Rezoning Transportation Analysis

Petition Number: #2022-089

Date	Description
11-28-22	First Review (TM)
01-25-23	Second Review (TM)
04-25-23	Third Review (TM)

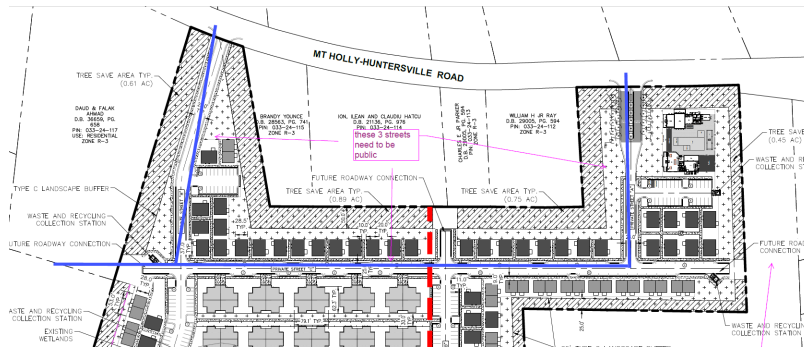
7. Site plan and conditional note(s) revisions are needed to commit private street A, B & C as public roadways. Public street C to stub to the western property line for a future roadway connection. The public roadways are to be designed to CLDSM standards U-03 to accommodate on-street parking. The Right-of-way, curb line and sidewalk are to be dimensioned from the roadway centerline. Add a conditional note committing to the construction of each public roadway.

Clarifying Comment (01-25-23): Add a conditional note committing to the construction of each public roadway. Identify each roadway as U-03 on the site plan and in the conditional note.

New Comment 04-25-23: Remove perpendicular parking from public streets. Parking along public roadways shall be parallel parking as shown in previous submissions. Public streets should be constructed to CLDSM standards including design of on-street parking and sidewalk.
